**ADDENDUM No. 2**  
Pine Grove Municipal Solid Waste Landfill Phase 5: Cells 5A – 5C  
RFP No. 26-0017

### PINE GROVE MSW LANDFILL – PHASE 5 CELLS 5A – 5C CONSTRUCTION

PINE GROVE MSW LANDFILL  
PHASE 5 CELLS 5A - 5C CONSTRUCTION

PROJECT : G035-136  
ADDENDUM: 2  
SKETCH : 1  
SHEET REVISED: C-201  
SCALE: N.T.S.  
DATE: 04/02/26  
BY: JLY

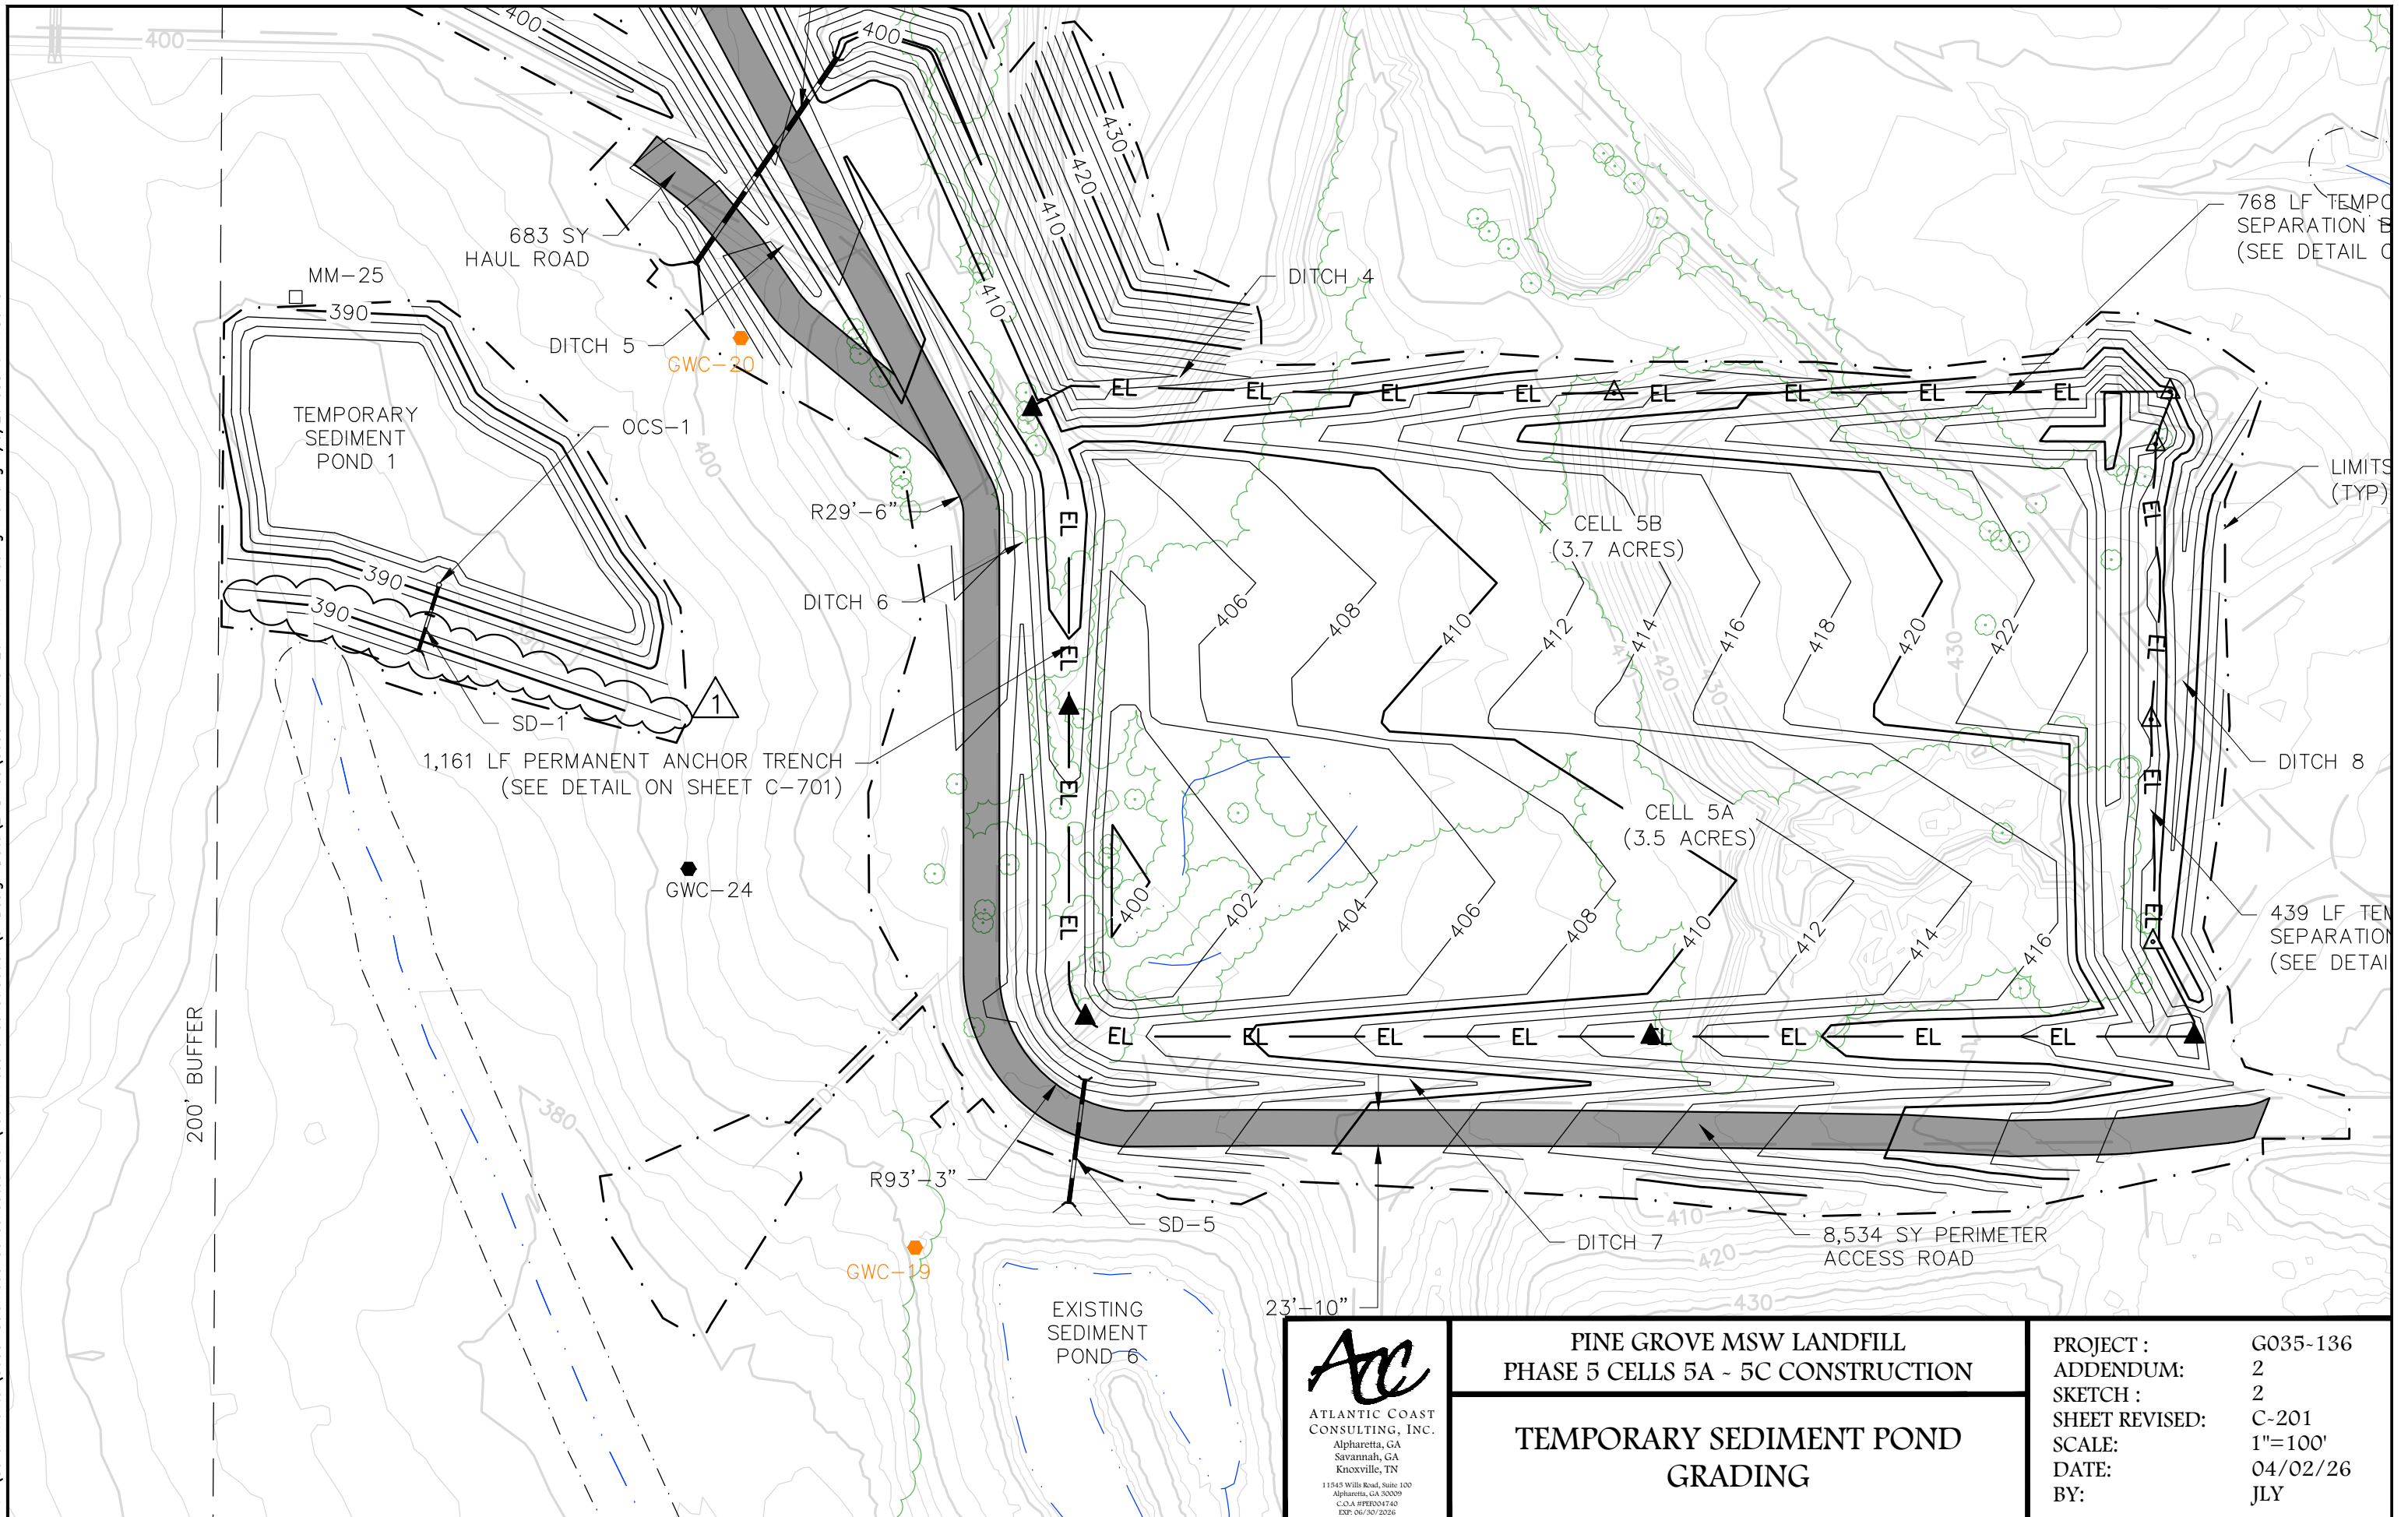
Revised Sheet C-201 in accordance with Sketch 1 and Sketch 2 included with this addendum.

PIPE ID	DIAMETER AND MATERIAL (INCHES)	LENGTH (FT)	INLET STRUCTURE	INV IN	INV OUT	OUTLET STRUCTURE
SD-1	(1) 36 CPP <sup>1</sup>	42	OCS-1	386.0	385.0	HW
SD-2	(1) 36 RCP	69	OCS-2	382.00	380.00	HW
SD-3	(2) 36 RCP	48	HW	391.00	390.00	HW
SD-4	(1) 48 CPP <sup>1</sup>	165	HW	400.00	399.00	HW
SD-5	(1) 30 RCP	82	HW	401.00	394.00	HW

PROJECT : G035-136  
 ADDENDUM: 2  
 SKETCH : 3  
 SHEET REVISED: C-705  
 SCALE: N.T.S  
 DATE: 04/02/26  
 BY: JLY

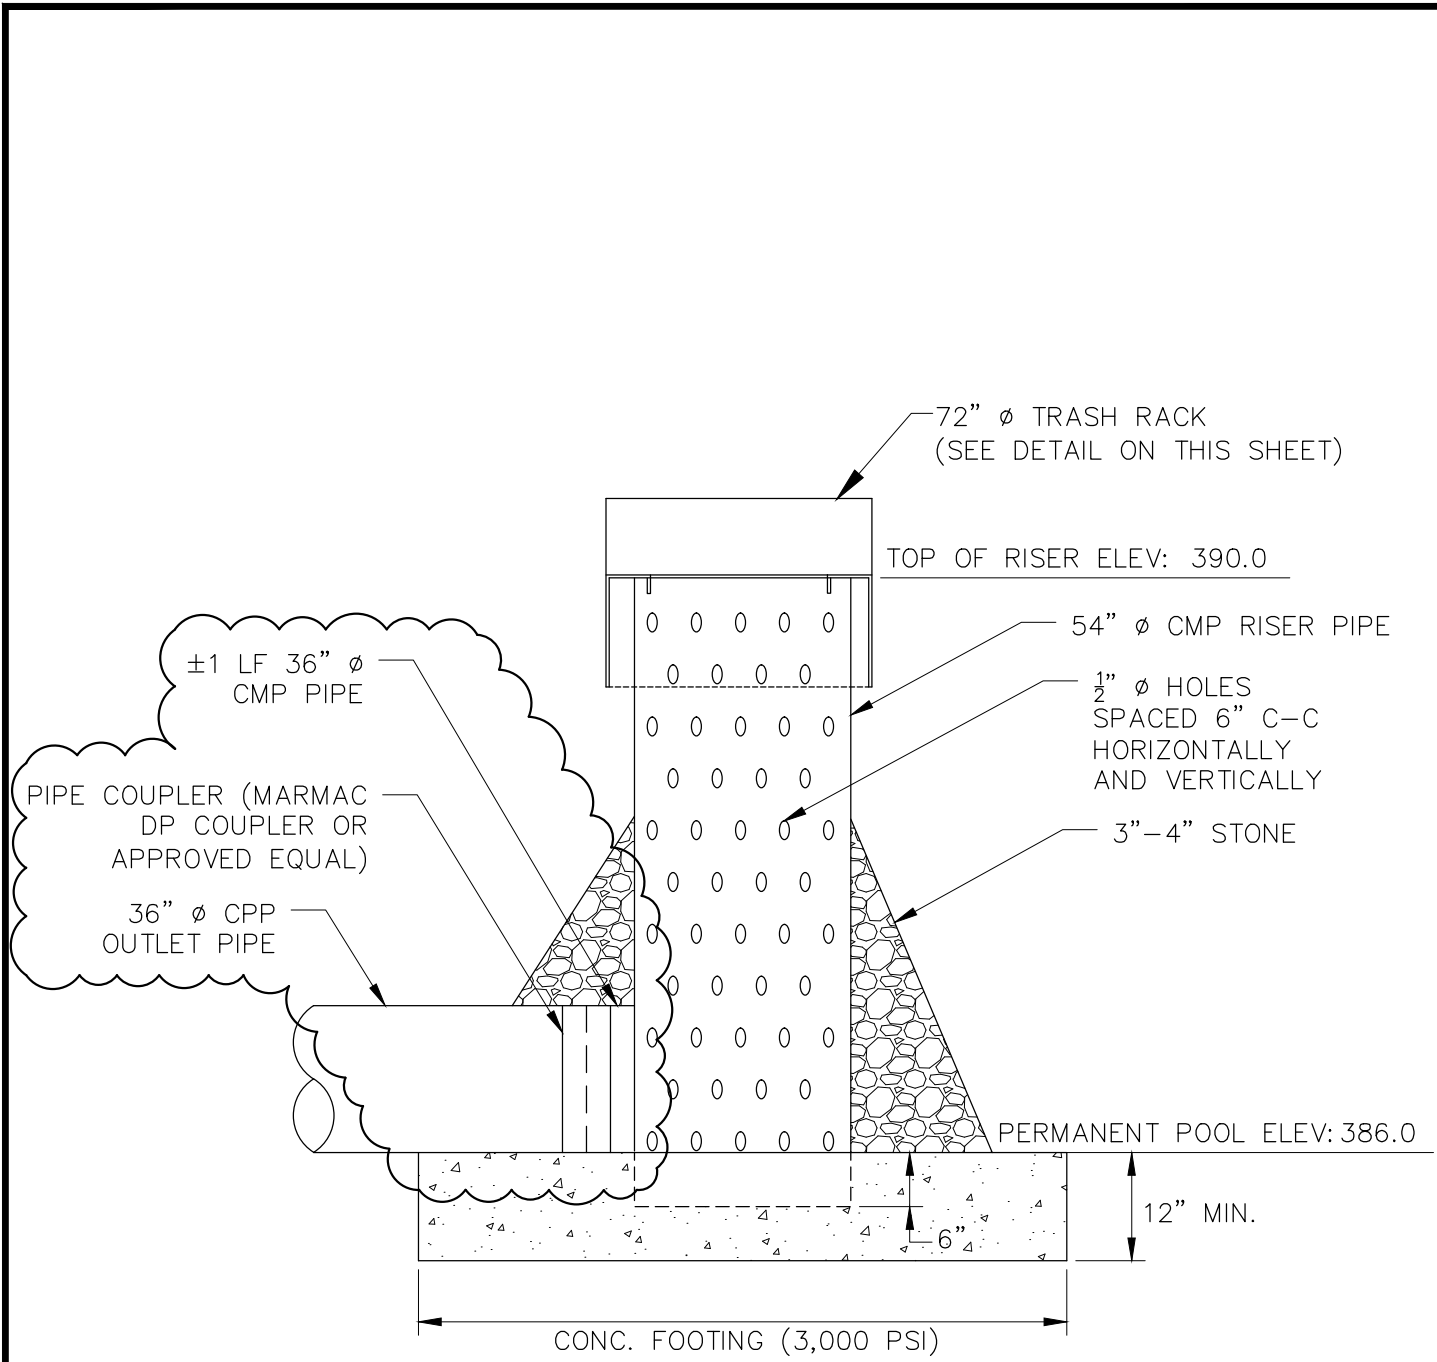
Revised Sheets C-705 in accordance with Sketch 3 and Sketch 4 included with this addendum.

SEDIMENT POND TABLE															
POND	TOP OF RISER EL/ STORAGE VOLUME OF BASIN		SEDIMENT REMOVAL VOLUME		TOP OF DAM EL:	EMERGENCY SPILLWAY CREST EL:	TRASH RACK DIAMETER	RISER DIAMETER	TOP OF DAM WIDTH	PRINCIPAL SPILLWAY DIAMETER	PRINCIPAL SPILLWAY INVERT UP EL:	PRINCIPAL SPILLWAY INVERT DOWN EL:	PRINCIPAL SPILLWAY LENGTH:	SPILLWAY STORAGE DEPTH	SIDE SLOPE
	FT	CY	CY	FT	FT	FT	IN	IN	FT	IN	FT	FT	FT	FT	FT:FT
	A	B	C	D	E	F	G	H	I	J	K	L	M	N	O
TEMP	390.0	7,491	2,121	386.0	392.8	391.5	72	54	15	36	386.0	385.0	42	1.5	3.0
7	387.4	14,015	4,757	383.0	390.0	388.4	84	60	15	36	382.0	380.0	69	1.0	3.0
